Subject: Duke Energy Corporation
Catawba Nuclear Station, Units 1 and 2
Docket Numbers 50-413 and 50-414
Response to Request for Additional Information (RAI)
for Proposed Technical Specification Amendment
TS 3.4.3 - Reactor Coolant System (RCS) Pressure and
Temperature (P/T) Limits
TS 3.4.6, RCS Loops - MODE 4
TS 3.4.7, RCS Loops - MODE 5, Loops Filled
TS 3.4.10, Pressurizer Safety Valves
TS 3.4.11, Pressurizer Power Operated Relief Valves
(PORVs)
TS 3.4.12, Low Temperature Overpressure Protection
(LTOP) System

The purpose of this letter is to docket Catawba's response to
your request for additional information dated June 9, 2003,
related to the subject submittal.

MARKED-UP TECHNICAL SPECIFICATIONS PAGES FOR CATAWBA

Figure 3.4.3-1
(UNIT 1 ONLY)
RCS Heatup Limitations

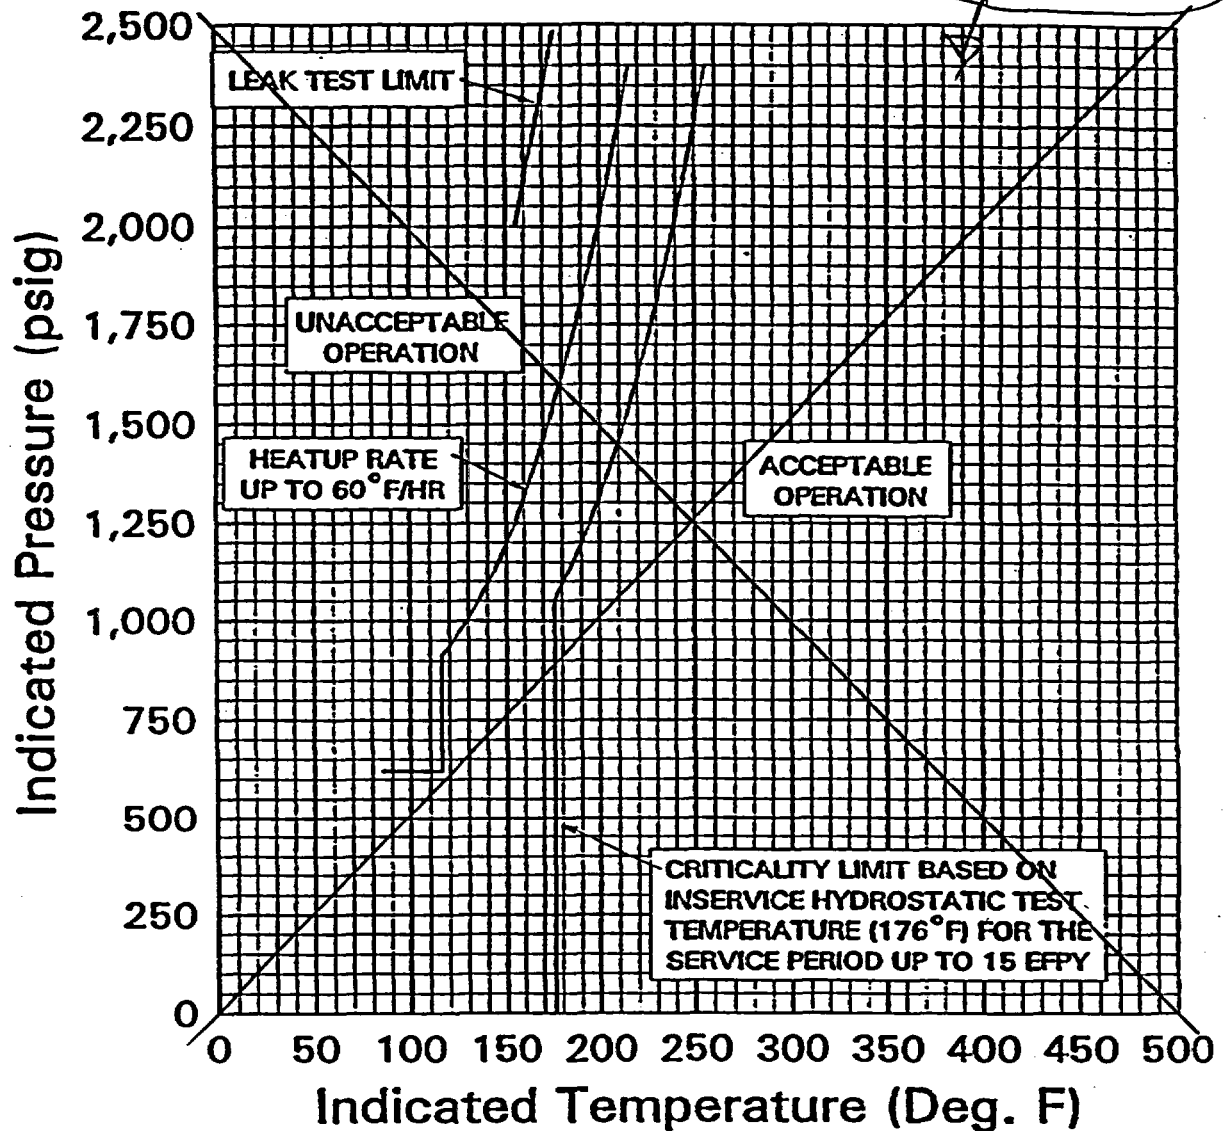
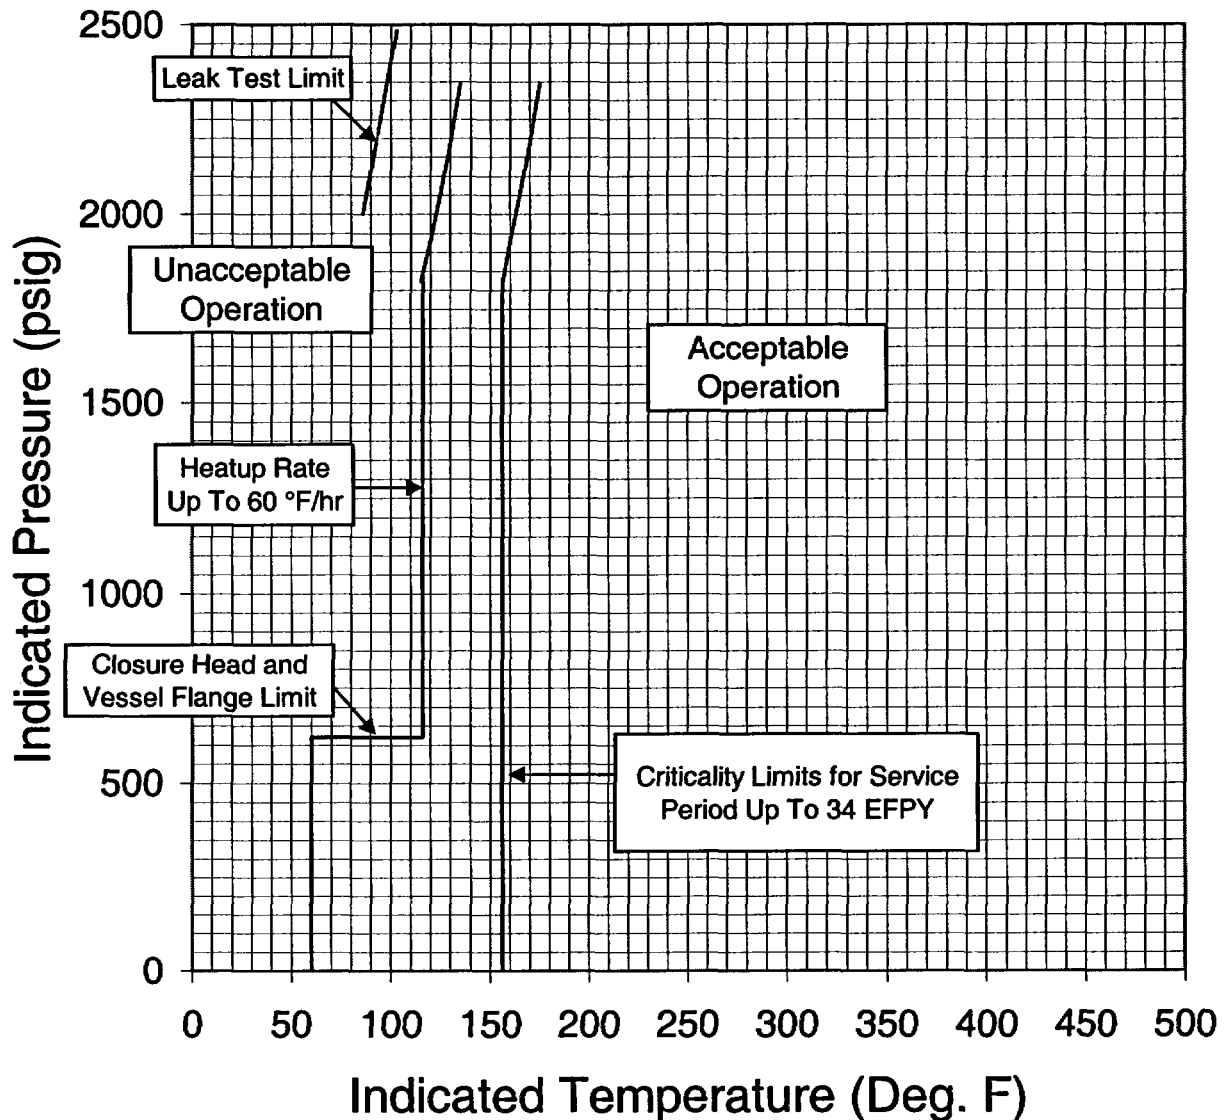
In a telephone call on May 22, 2003, the NRC staff requested two
items. The first was for Duke to revise the proposed P/T curves
for both units to remove some redundancy in the curves. This
will help reduce any areas of potential confusion for personnel
implementing the curves. In addition, the criticality limit
curve for reactor coolant system heatup on Unit 1 required
revision.

LIMITING MATERIAL: LOWER SHELL FORGING 64-05 $\frac{1}{2}$ 04
LIMITING ART AT 15 EPY: 1/4-T, 43°F (42)
34 3/4-T, 26°F (31)

*Insert
New
chart A*

Limiting Material: Lower Shell Forging 04
and Intermediate Shell Forging 05

Limiting ART at 34 EFPY: 1/4-T, 42°F
3/4-T, 31°F

Figure 3.4.3-1
(UNIT 2 ONLY)
RCS Heatup Limitations

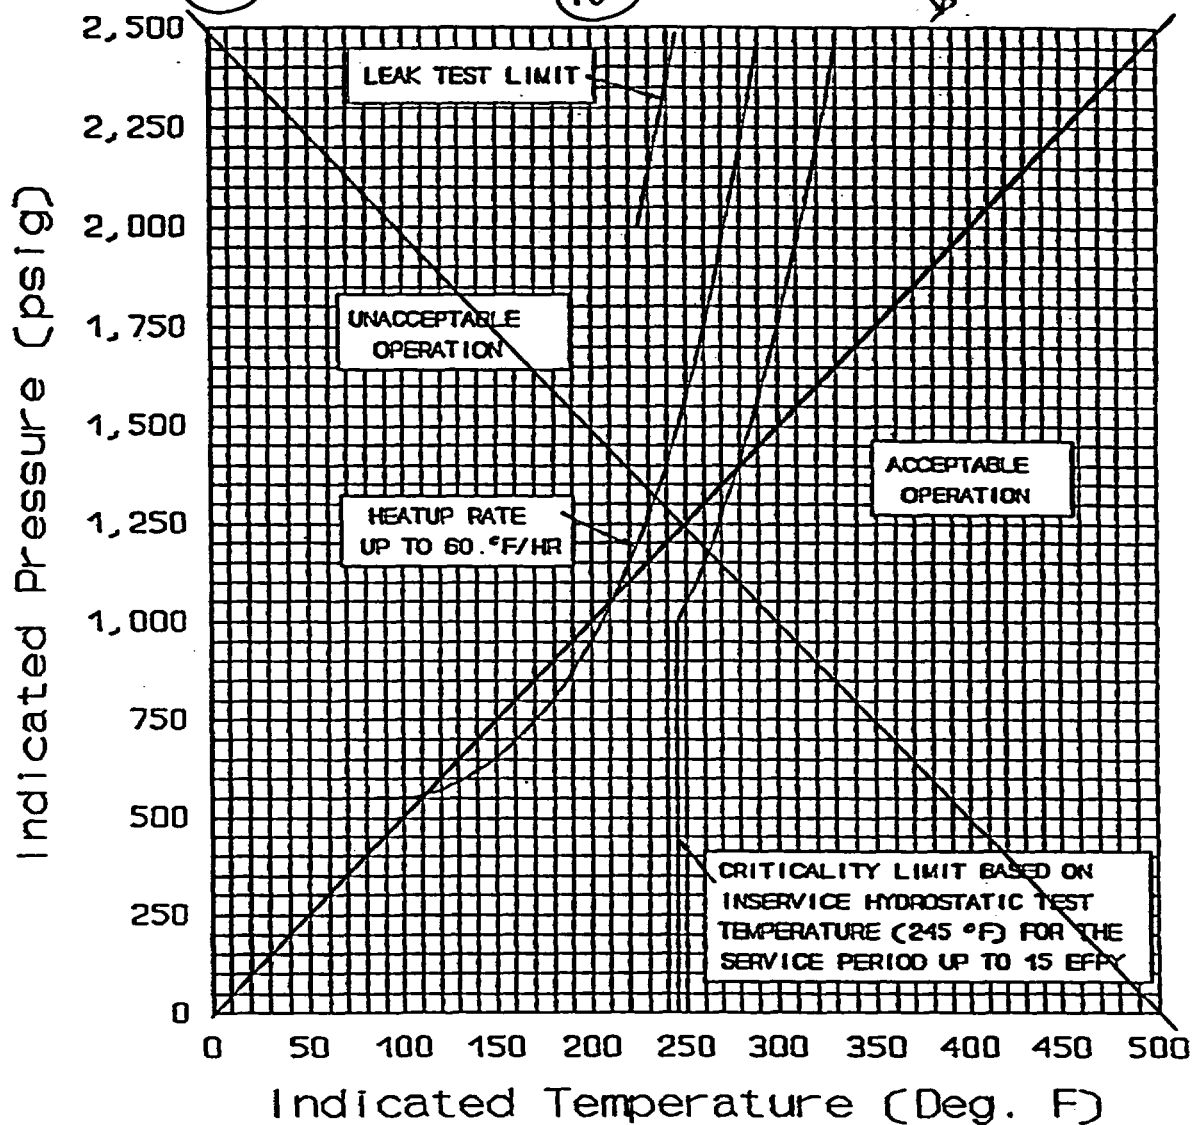
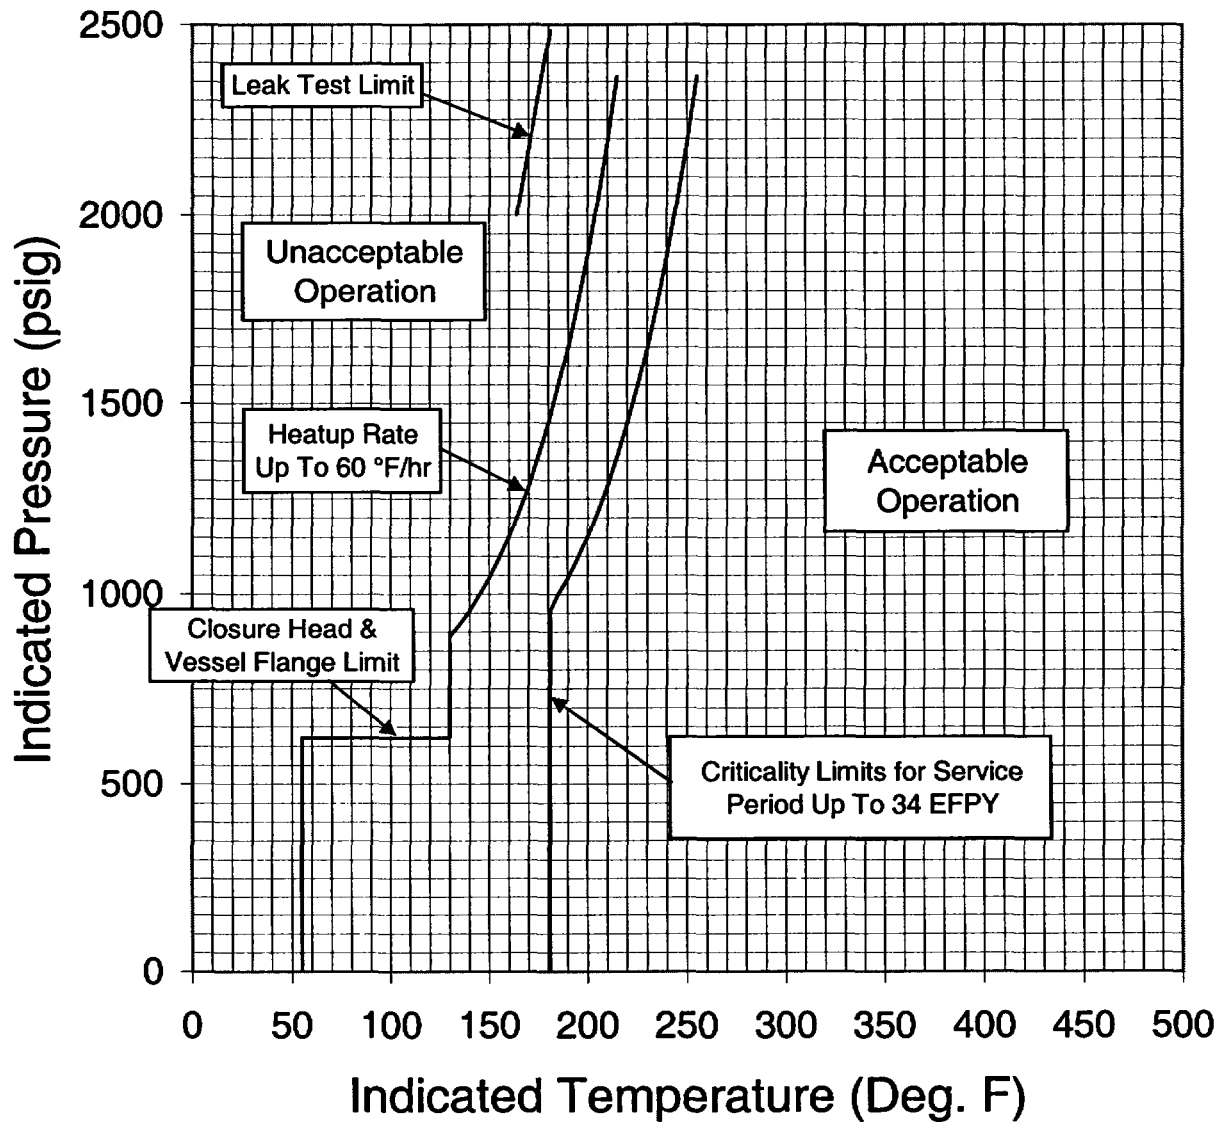
LIMITING ART AT 45 EPFY: 1/4-t, 412.6 °F

3/4-t, 96.0 °F

Insert New
Chart B

Limiting Material: Intermediate Shell, B8605-2

Limiting ART at 34 EFPY: 1/4-T, 121°F

3/4-T, 106°F

Figure 3.4.3-2
(UNIT 1 ONLY)
RCS Cooldown Limitations

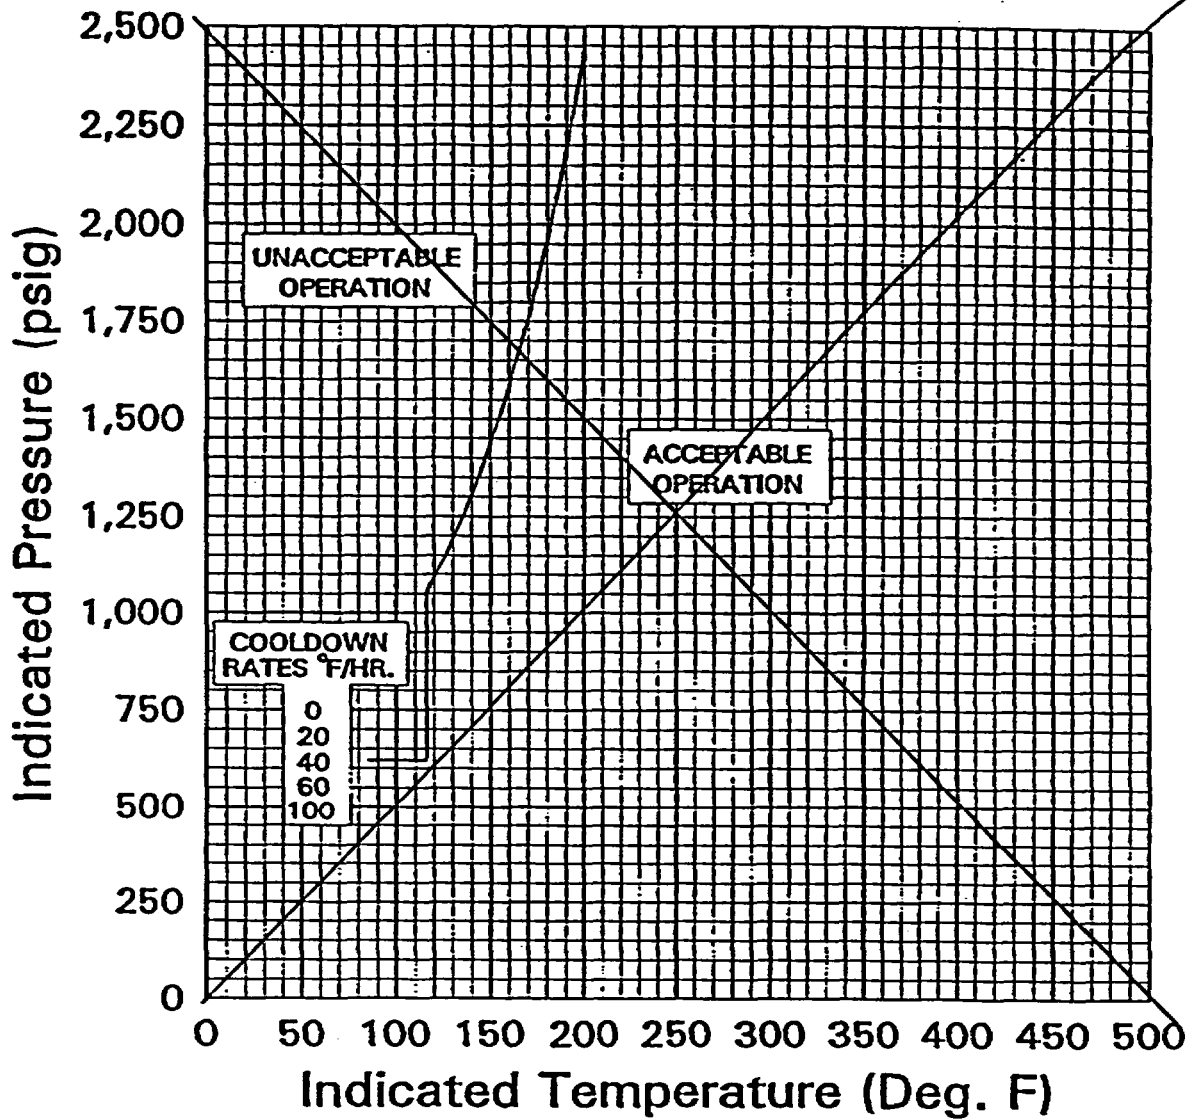
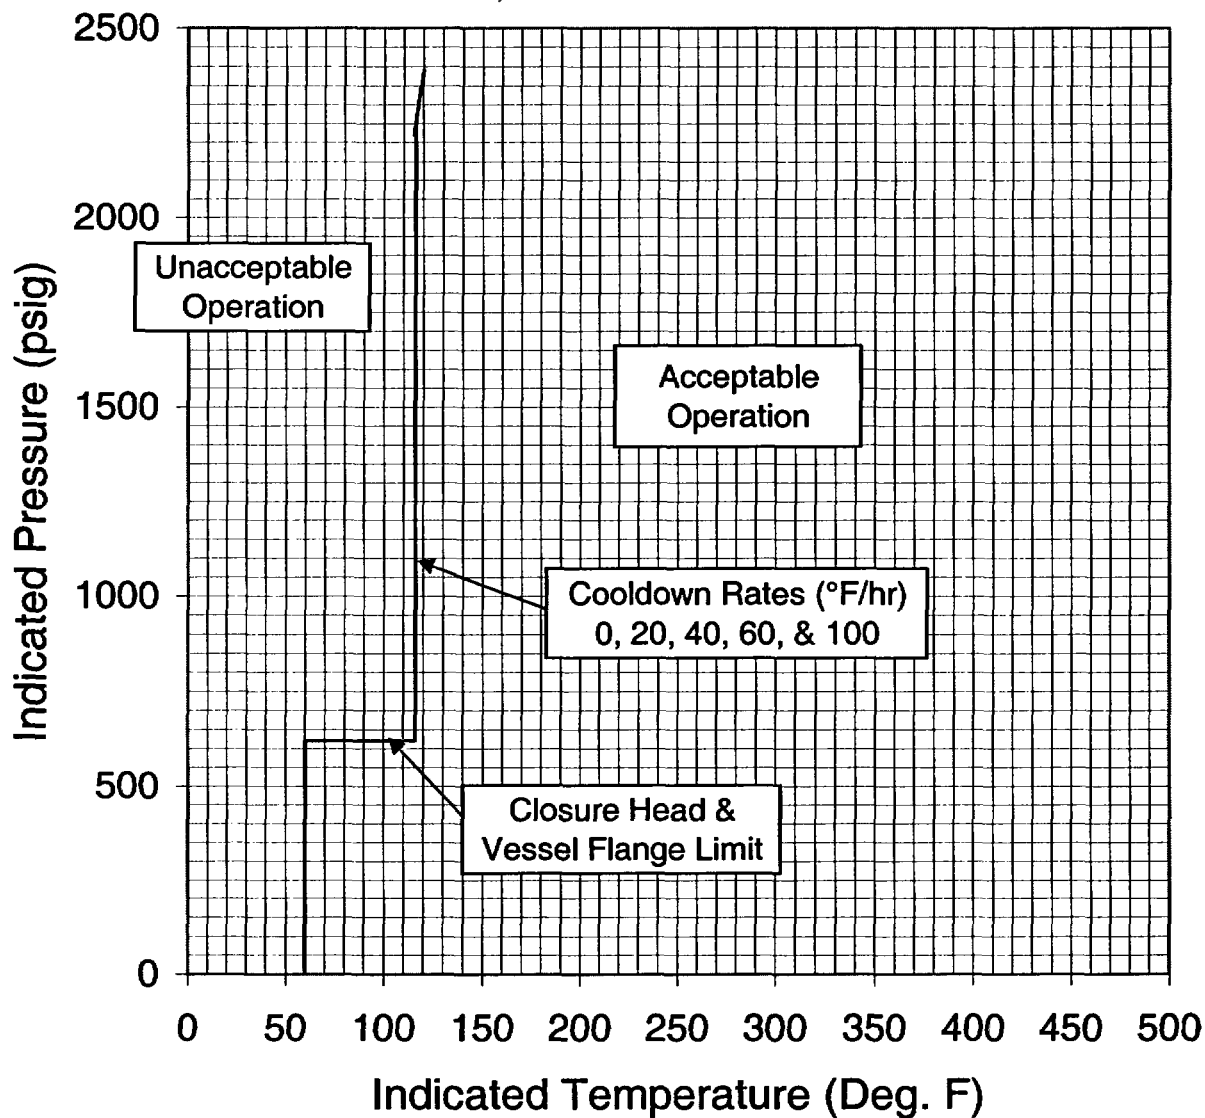
LIMITING MATERIAL: LOWER SHELL FORGING 04 05 $\frac{1}{2}$ 04
 LIMITING ART AT 15 EPF: 1/4-T, 43°F (42)
 3/4-T, 86°F (31)

Insert New Chart C

Limiting Material: Lower Shell Forging 04
and Intermediate Shell Forging 05

Limiting ART at 34 EFPY: 1/4-T, 42°F
3/4-T, 31°F

Figure 3.4.3-2
(UNIT 2 ONLY)
RCS Cooldown Limitations

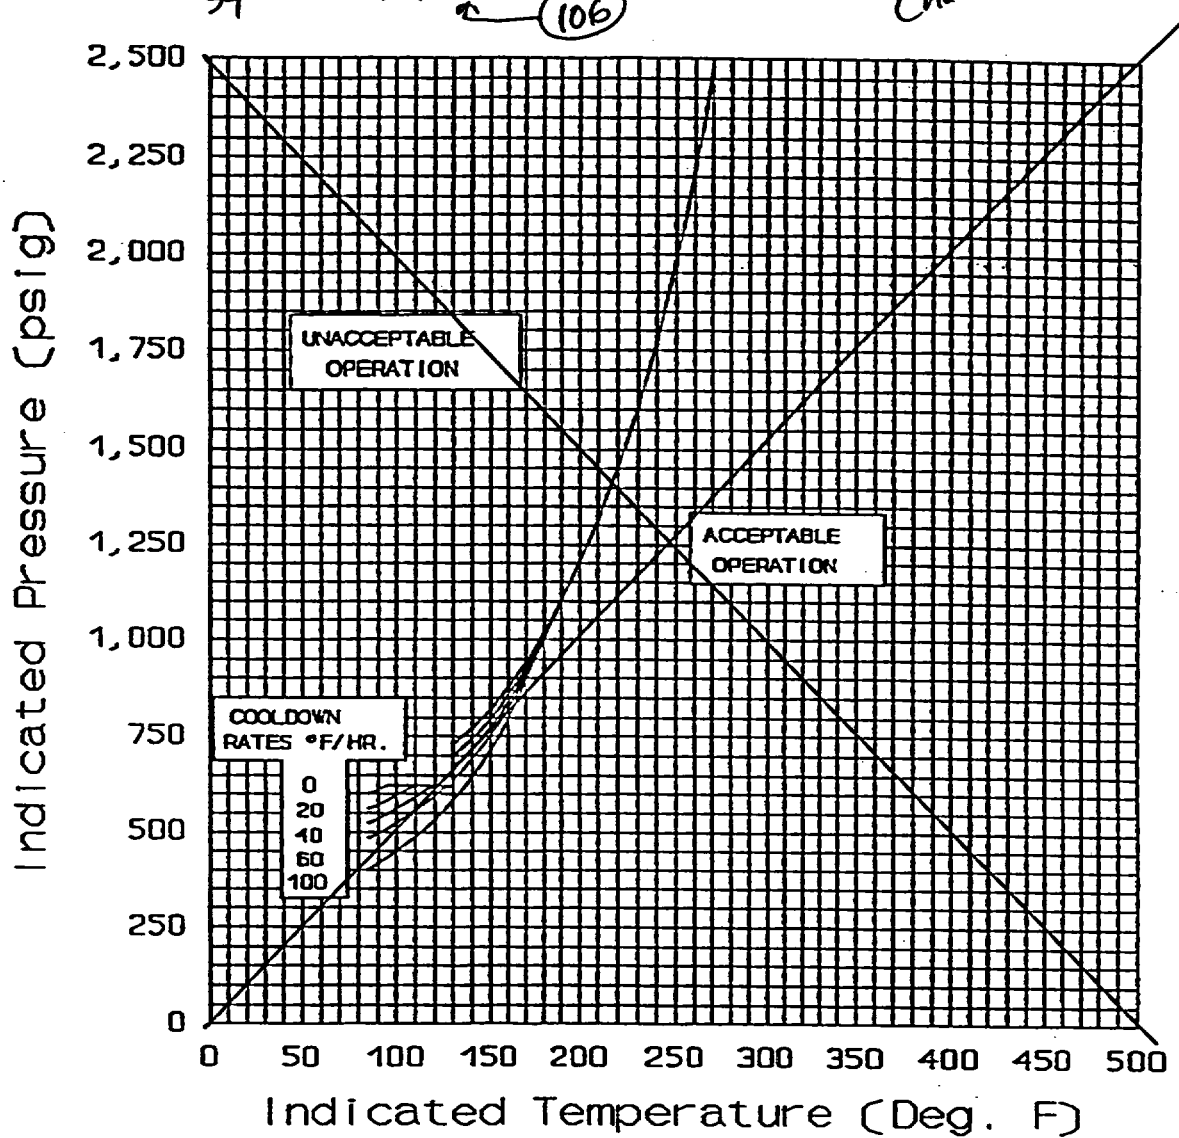
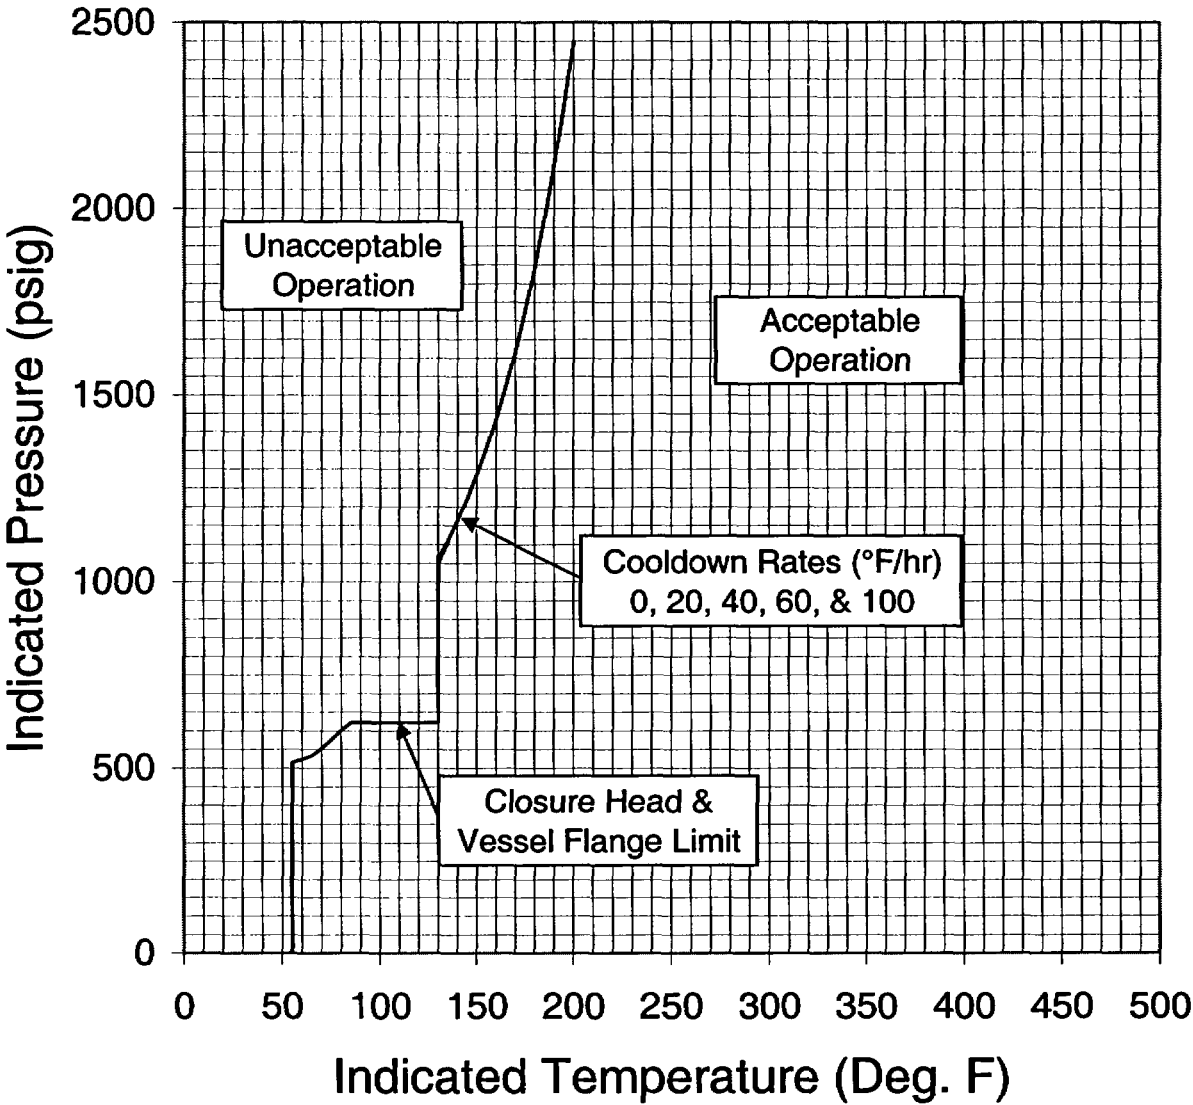
LIMITING ART AT 45-EFPY: 1/4-L, 112.6 F

3/4-L, 96.8 F

Insert New Chart D

MATERIALS PROPERTY BASIS
Limiting Material: Intermediate Shell, B8605-2
Limiting ART at 34 EFPY: 1/4-T, 121°F
3/4-T, 106°F
